Subject: AP1000 Response to Request for Additional Information (TR 44)

Response to Request for Additional Information on Technical Report No. 44

RAI Response Number: RAI-TR44-016

RAI Response Number: RAI-TR44-017
Revision: 2

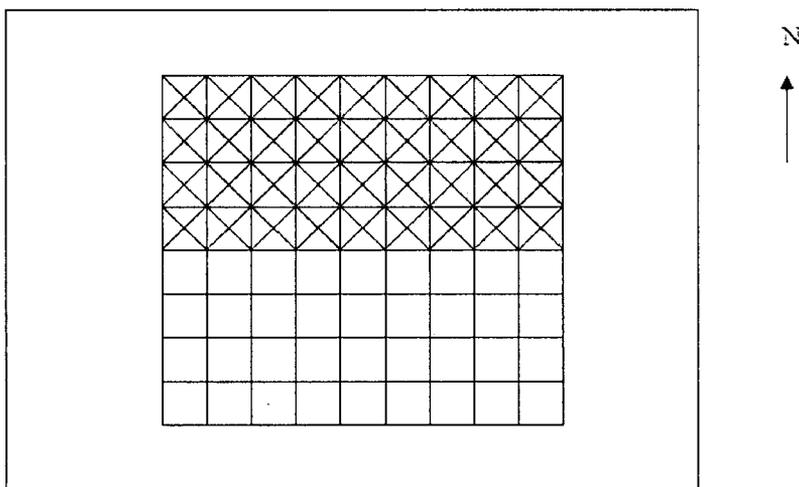
Explain whether only a full fuel rack is considered in the simulation, or if several scenarios are considered; i. e., different fill ratios, from empty to full. Provide the technical justification if only a full rack is considered.

Following the August 2009 audit with the NRC, Westinghouse has completed an additional run (Run Number 4) to examine the effects of the worst possible partial rack loading scenario (half full, all on one side, as depicted in the following figure). The results of this additional run will be included in Revision 2 of TR-44. Also, DCD Section 9.1.1.2.1, Item A, is modified to indicate that a partially filled loading case was evaluated.

Replace DCD Figure 9.1-1 with the following figure:

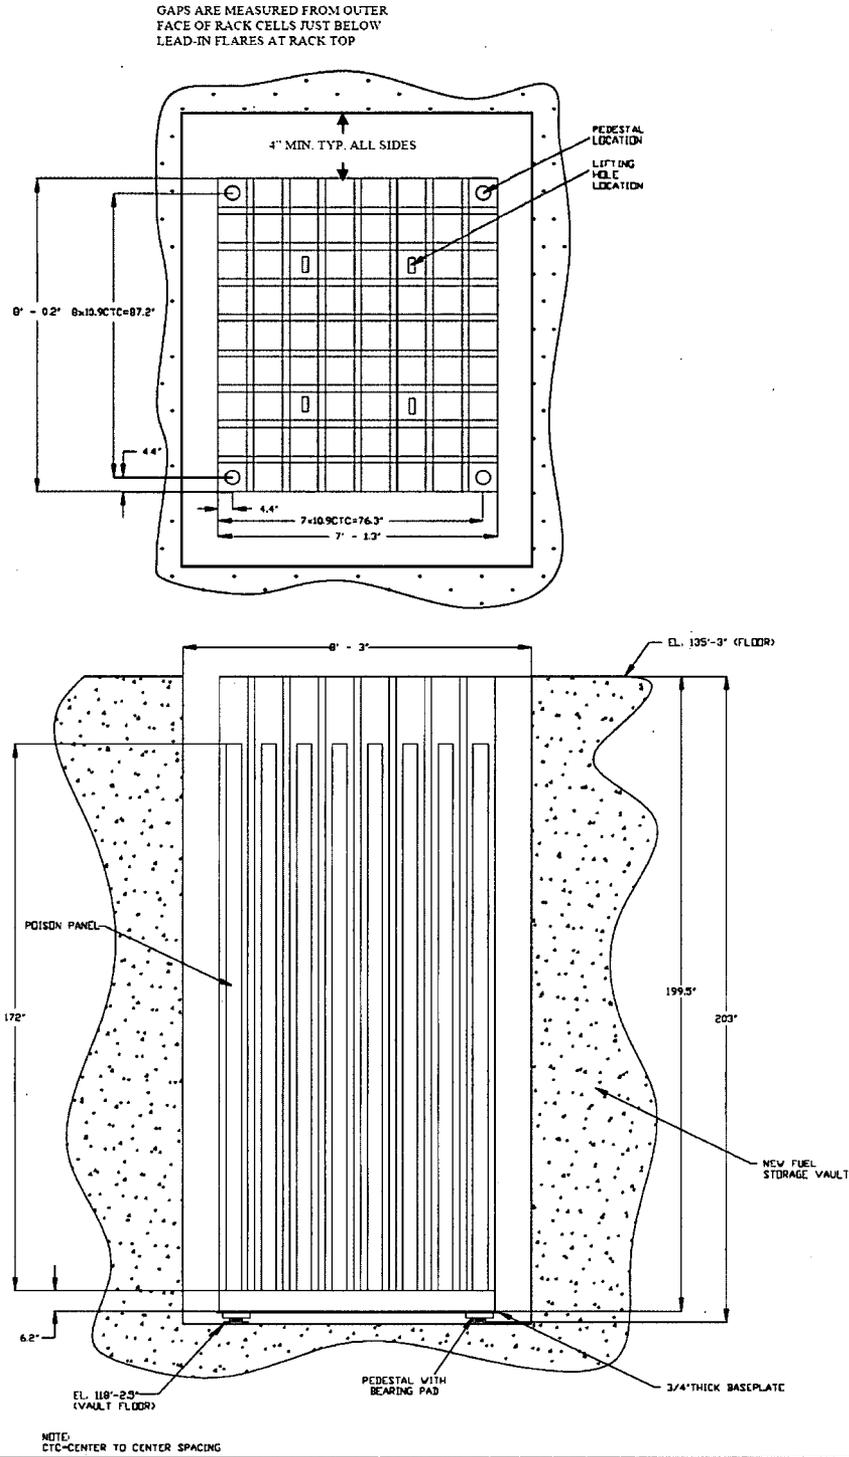
What are the gaps and tolerances for each of the gaps between the fuel assembly and cell wall, and between the rack and vault wall? What are the assumed initial locations of the various components (fuel assemblies and rack) and what is the technical basis for this assumption. Were any studies done for different initial conditions (considering tolerances); if not, explain why it was not necessary. Are there requirements in the DCD to ensure that the assumed gaps (considering tolerances) are maintained throughout the operating license period?

Following the August 2009 audit, Westinghouse is updating DCD Figure 9.1-1 to include additional details related to the placement of the New Fuel Storage Rack within the New Fuel Pit. Figure 9.1-1 will be updated as shown in the DCD Revision section below to show the general position of the rack within the pit, including a definition of the minimum gaps. The only changes to the figure are that the rack is now shown within the vault and the 4 inch minimum typical gap dimension along with the clarifying note about where the gaps are measured from have been added. The 4 inch minimum gap is conservative based on the maximum rack displacement of 3.2 inches (which occurs at the top of the rack; the maximum displacement at the baseplate elevation is only 0.5 inches) when the 0.2 COF is ignored (justification for ignoring the 0.2 COF case is discussed in the response to RAI-SRP9.1.2-SEB1-02, Revision 1).
